Value Engineering Study Report

*Projects – STP – 9108(4)(5)
P.I. Nos.. –751770 & 751775*

Widening of Battle Creek Road – Mt. Zion Blvd.

RE: Submittal of the final Value Engineering Report
Projects – STP -9108 (4) (5)
Clayton County
P.I. Nos. – 751770 & 751775
Widening of Battle Creek Road – Mt. Zion Blvd.
PBS&J Project Task Order No. 25

ALTERNATIVE NO.:
 RD-1

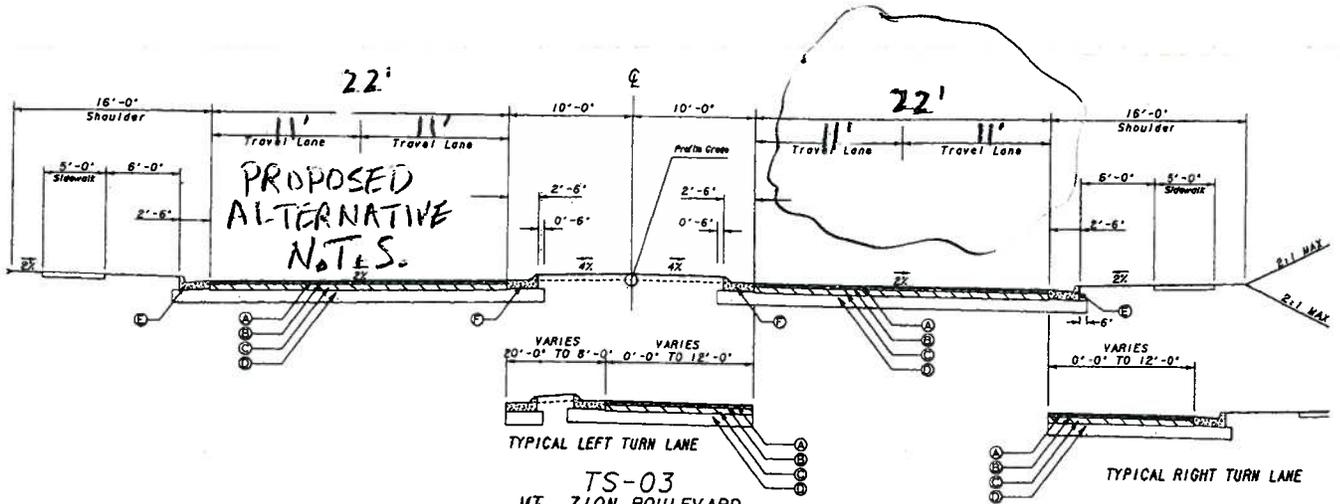
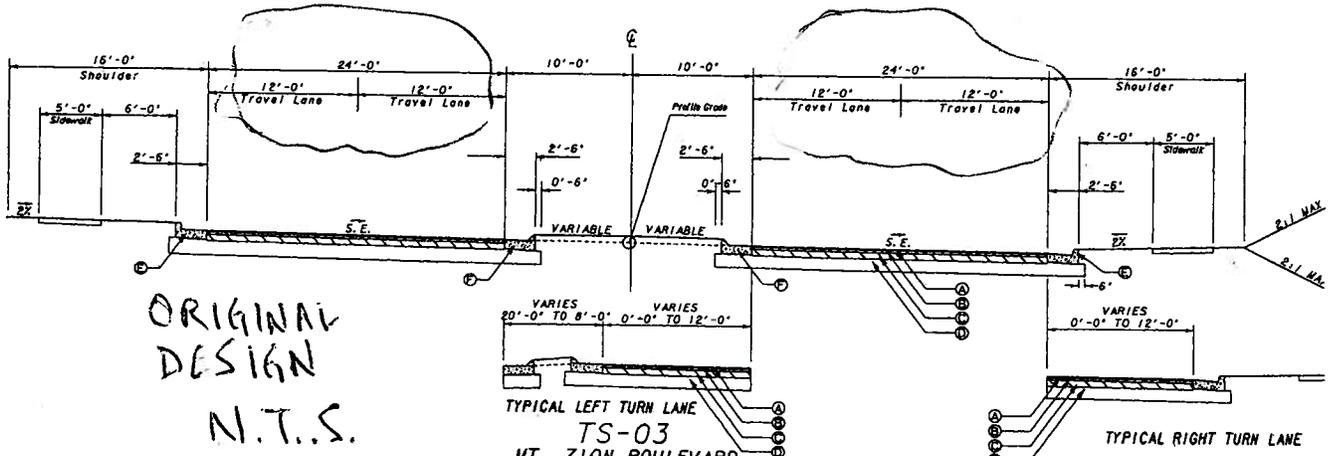
The original design utilizes 12'-0" travel lanes throughout the project.

The alternative design proposes using 11'-0" travel lanes throughout project.

Reduction of width of travel lanes throughout the project would result in 4' of full build-up widening and bridge width that would not have to be constructed, resulting in significant cost savings. Although 11' lanes would require an exception to GDOT policy, AASHTO's "Policy on Geometric Design of Highways 2004" states that 11'-0" lanes are permissible. It also states that under interrupted-flow operating conditions at low speeds (45 mph or less), narrower lanes are normally adequate and have some advantages. (See Pages 472-473). Due to the low speed (45mph), low % trucks and urban character of the project, 11'-0" lanes should pose no operational issues.

RD-2

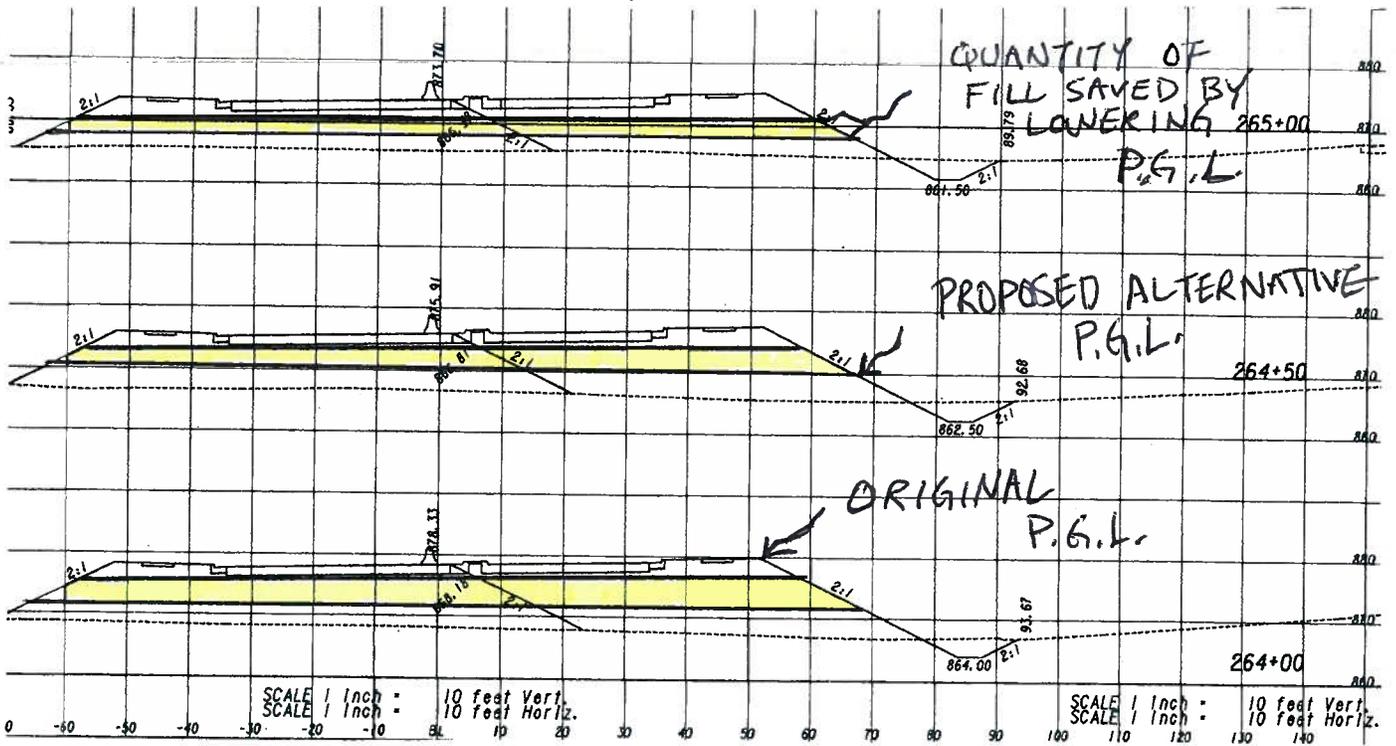
The original design shows the project requiring approximately 120,000 CY of fill to construct.

The alternative seeks to review the profile grade to see if it may be lowered to reduce the amount of fill required to complete the desired widening.

The intent of this alternative is to reduce the amount of fill required to construct the desired widening. Project # STP-9108(5) shows an overall cut of approximately 7,700 CY for the project. Project # STP-9108(4) shows approximately 127,000 CY of fill required to construct to the proposed P.G.L. Absent compelling circumstances, revisit the profile grade to adjust to minimize fill where practicable, particularly on Project STP-9108(4).

- LOWER P.G.L. IN SELECTED AREAS
TO REDUCE BORROW REQUIRED TO
CONSTRUCT PROPOSED WIDENING.

RD-4

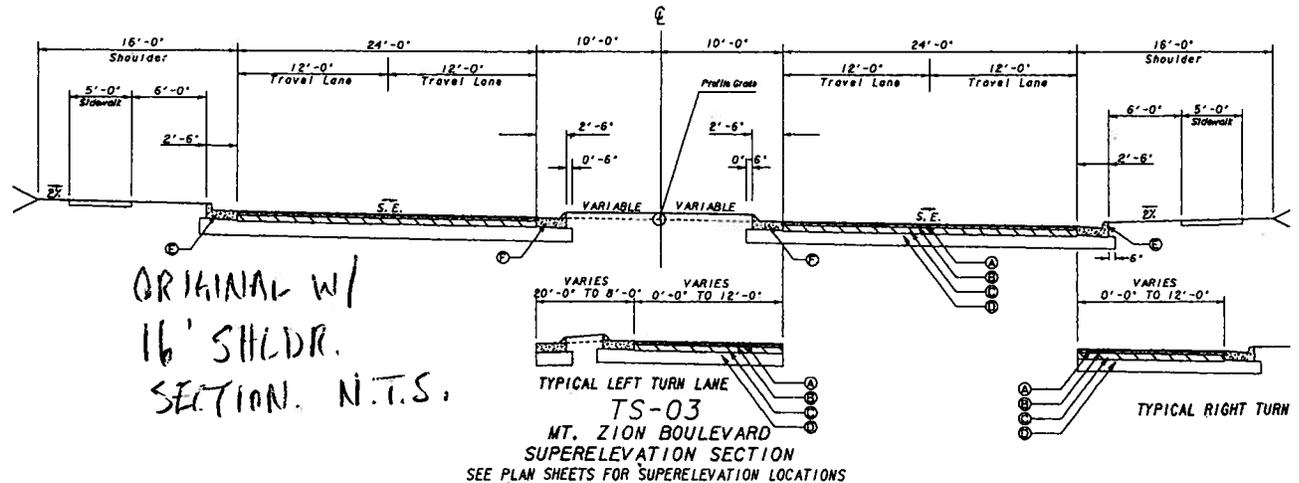
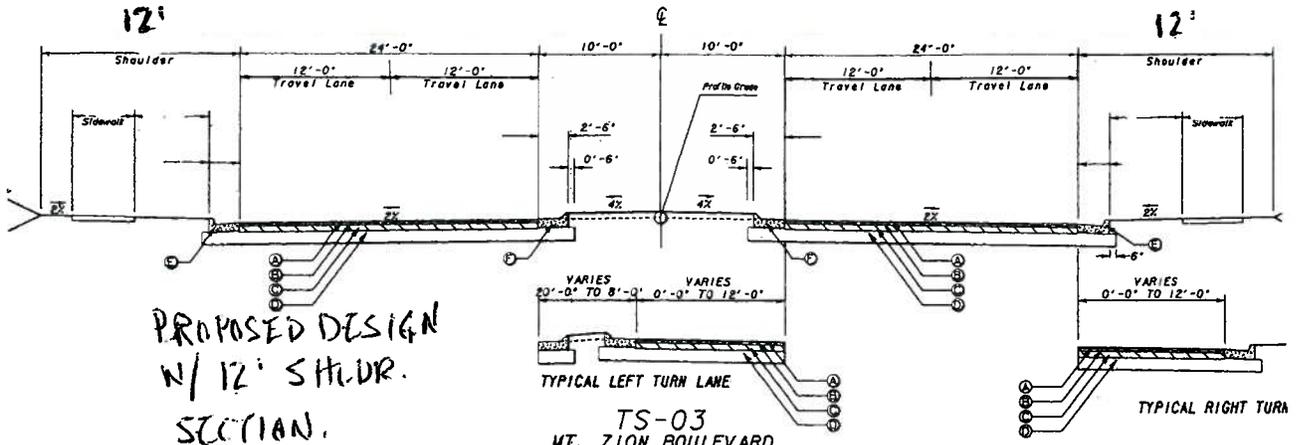
DESCRIPTION: USE A 12' SHOULDER IN LIEU OF 16' PROPOSED

RD-6

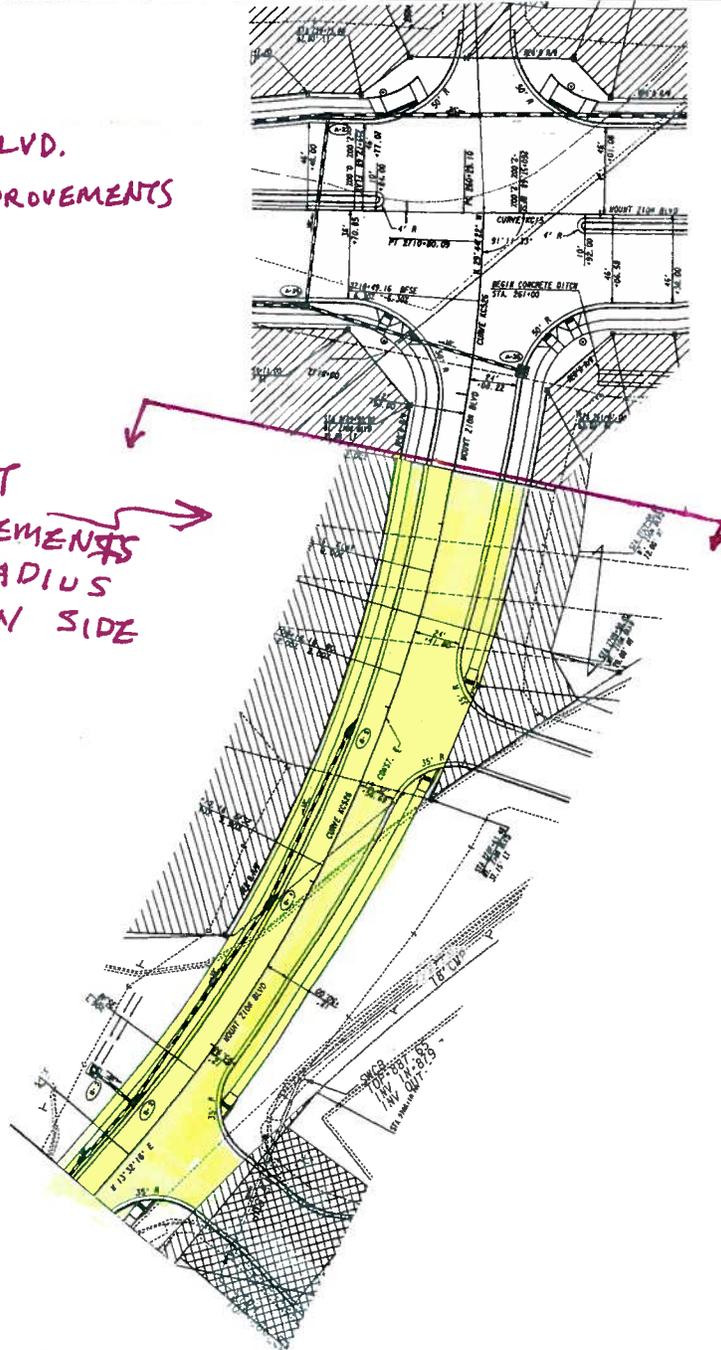
The proposed plans show a number of significant side street improvements throughout the project. The intent of the alternative is to reduce or eliminate side street improvements beyond the radius return. The illustrations and calculations take proposed improvements to Mount Zion Boulevard as an example. The cost savings shown are only for the improvements beyond the radius return on Mount Zion Boulevard. While suggesting deleting or limiting side street improvements, it is noted that replacement of in-kind features, as well as appropriate slope and drainage ties must be made.

DESCRIPTION: LIMIT SIDE ROAD IMPROVEMENTS.

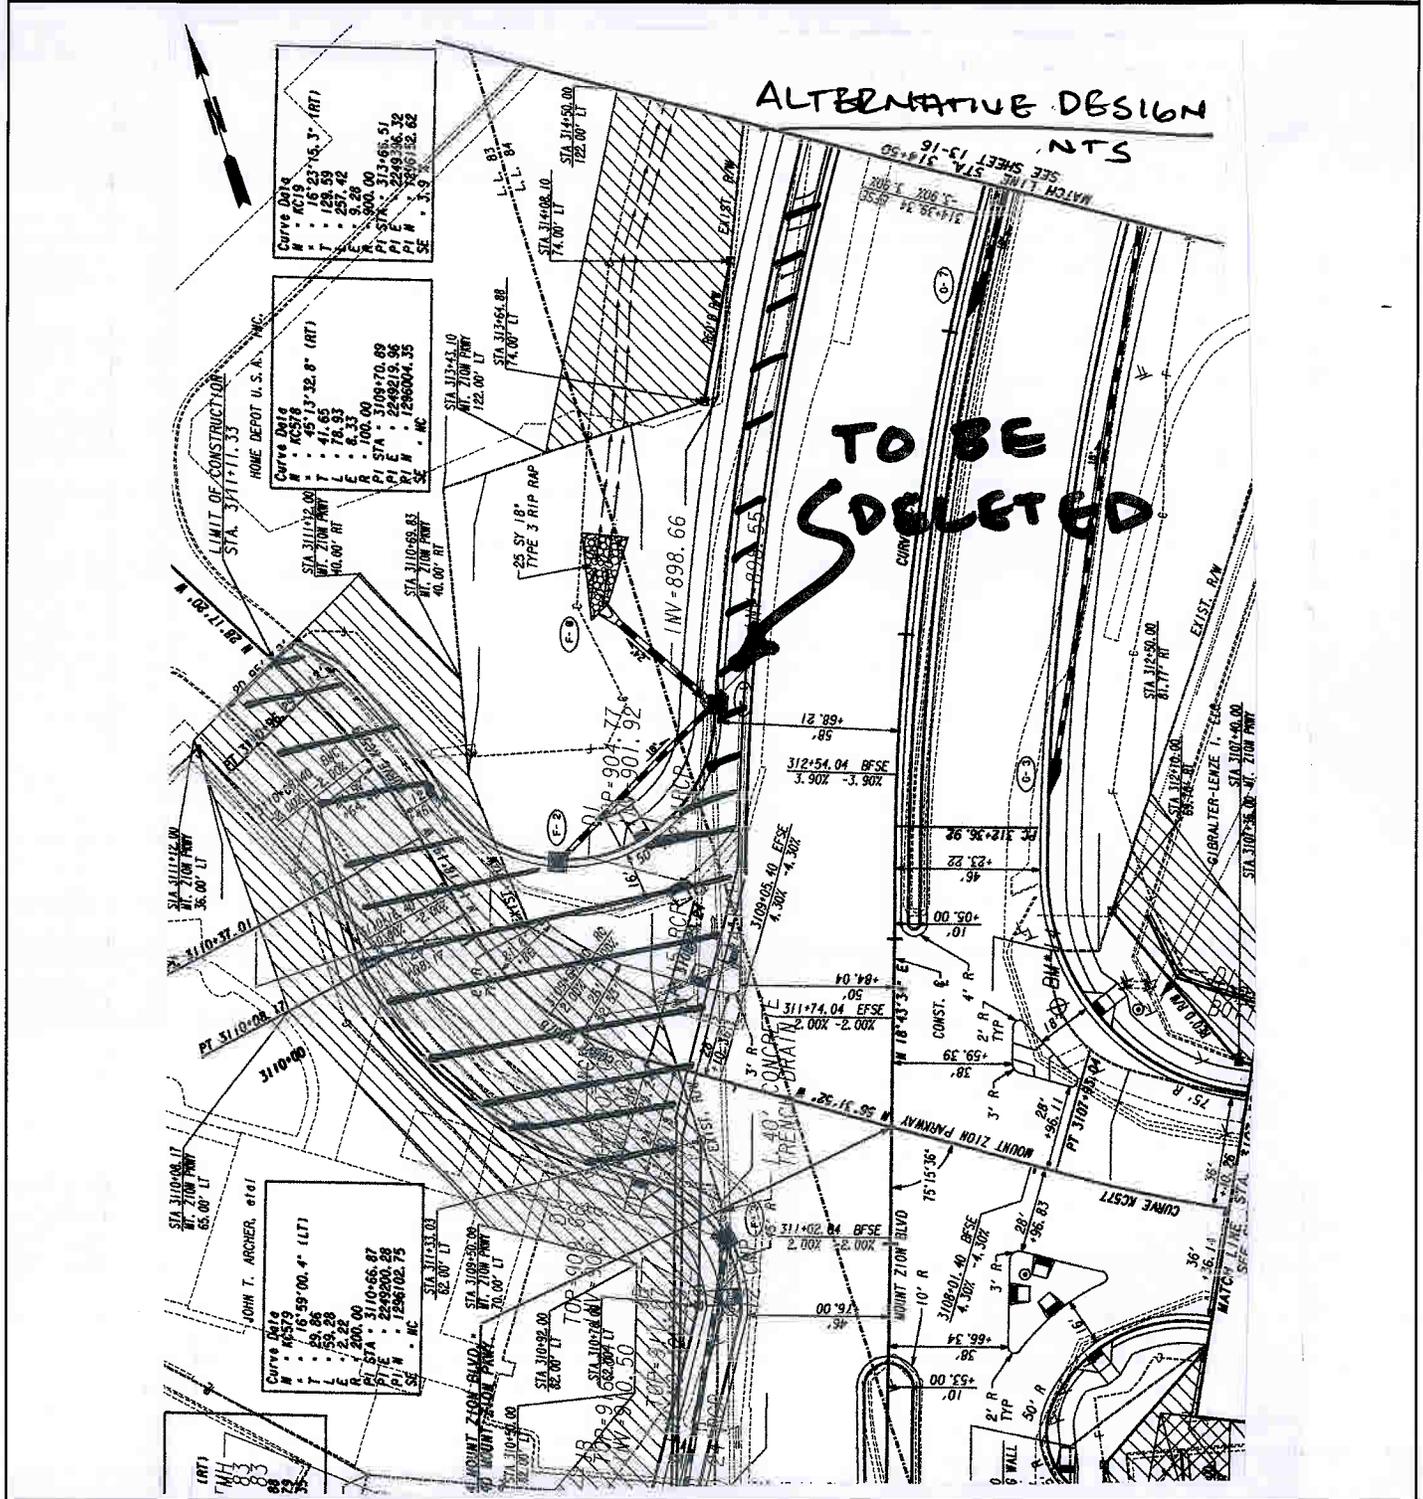
Design year traffic projections predict poor operations on Mount Zion Boulevard from Mount Zion Road through the I-75 Intersection. The close proximity of the three intersections creates operational problems for this area. Closing the median opening may provide some benefit however due to the amount of development on Mount Zion Parkway, simply closing the median opening may create other issues which should be investigated. A more feasible option may be to modify the intersection to reduce the number of signal phases and provide a right-in, right-out and left-in with no through movements.

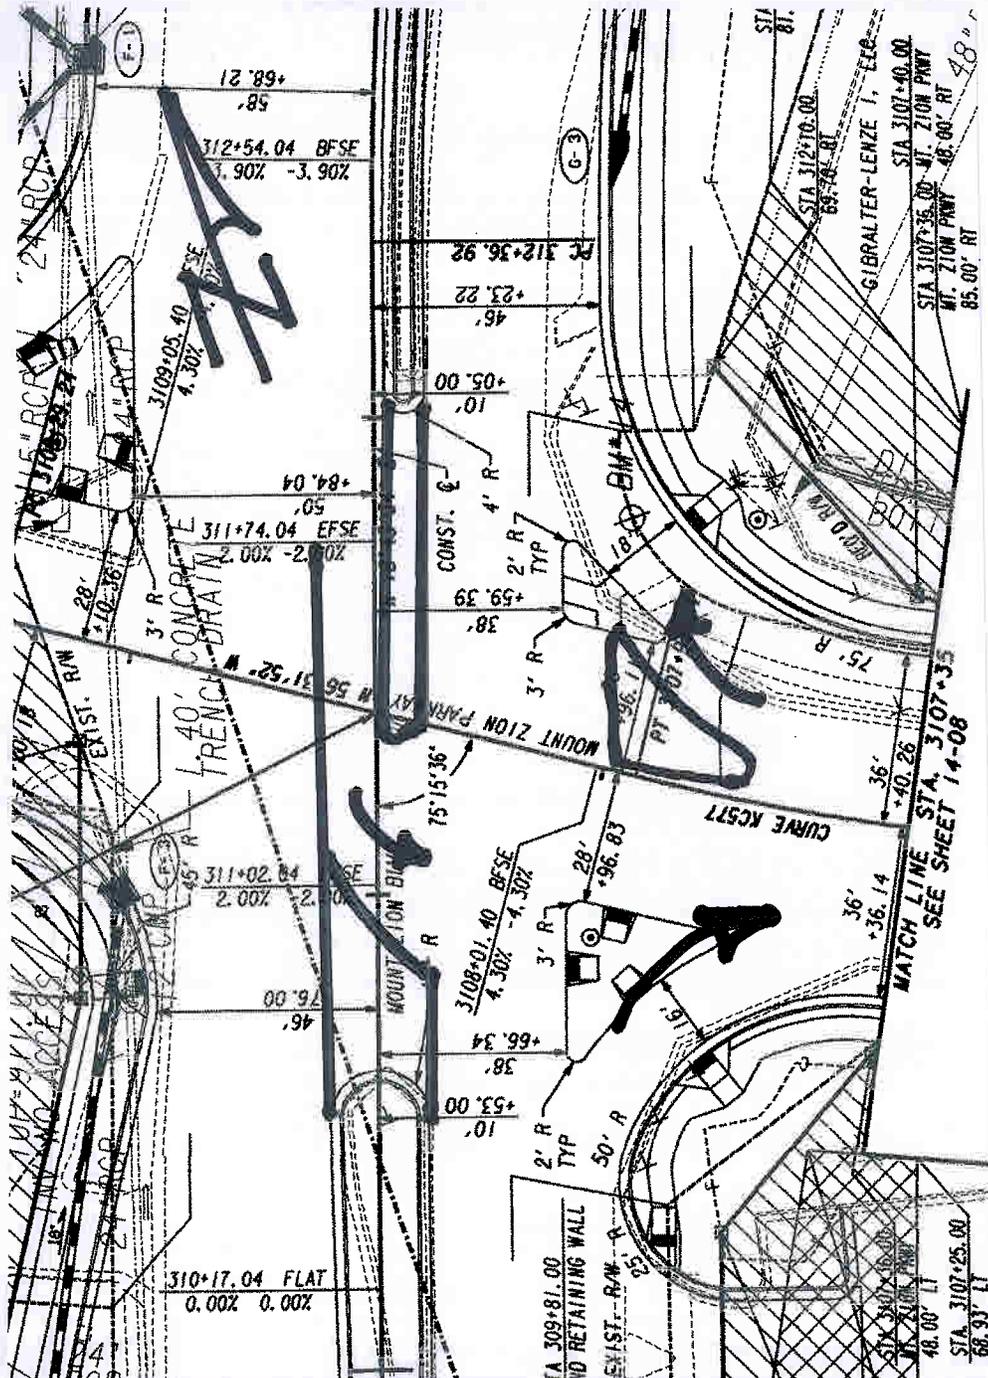
Design year traffic projections predict a LOS F on the southbound exit ramp from I-75 to Mount Zion Boulevard. The primary cause for the breakdown in LOS appears to be congestion caused by the access to Home Depot. Elimination of this connection combined with extending the channelized right turn for traffic turning northbound on Mount Zion Road should not only improve the traffic flow on the I-75 exit ramp but also improve the operation of the Mount Zion Road / Mount Zion Boulevard intersection.

DESCRIPTION: USE SINGLE CELL PRECAST CONSPAN IN-LIEU OF BOX CULVERT AT PANTHER CREEK SHEET NO.: 2 of 4

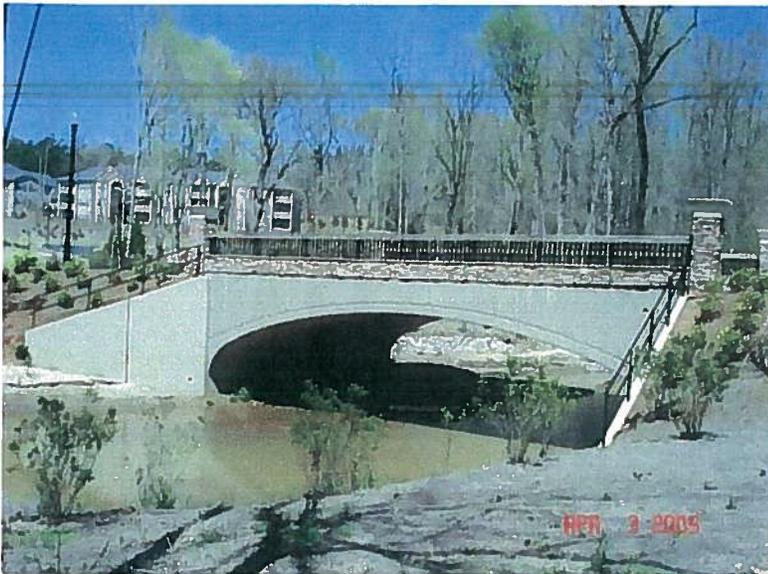
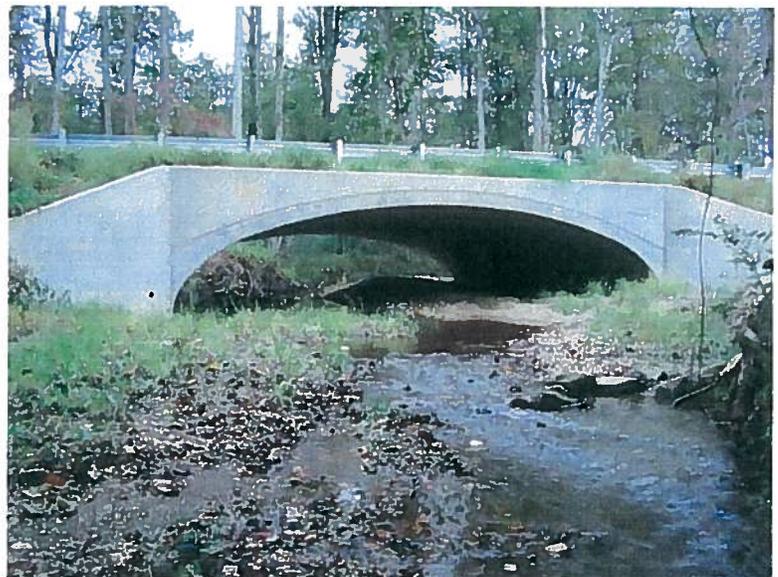
CONSPAN pre-cast culverts are a proven construction option of choice to many agencies (DOT’s and Municipalities). The ability of the system to provide larger spans and the ease of construction can be beneficial to the situation in this project where wetland mitigation and stream bed remediation is a concern.
